Technical Service Bulletin

Subject: Water intrusion may happen in the V-mux communication harness located front of chassis.

Applies To: All Rosenbauer Commander, Warrior, and Avenger chassis with a build date from 06/2016 to 10/2018.

TSB-012221

Improved 8616703-001 V-mux Network Harness EXT

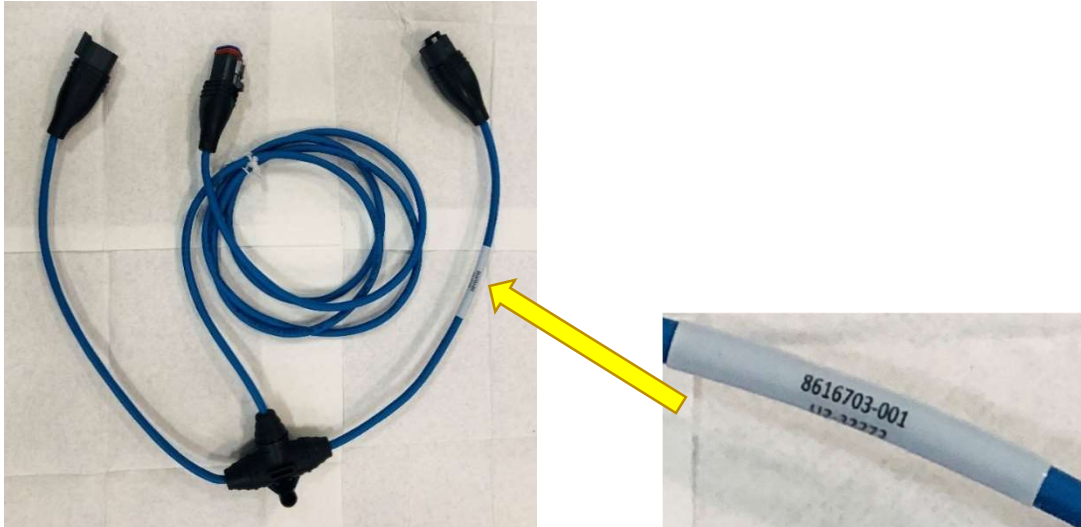
Condition: Water intrusion due to improper sealing of cabling and/or Deutsch "Y" connectors. See examples.

Examples of unsatisfactory conditions.

Correction: Replacement of data cabling "Y" with sealed waterproof connector. Tie up all connections and ensure "Y" cable connections is facing downward. If necessary, replace the Deutsch connector and pins opposite of the Improved Rosenbauer part number 8616703-001 V-mux Network Harness EXT. Copy and paste to see video
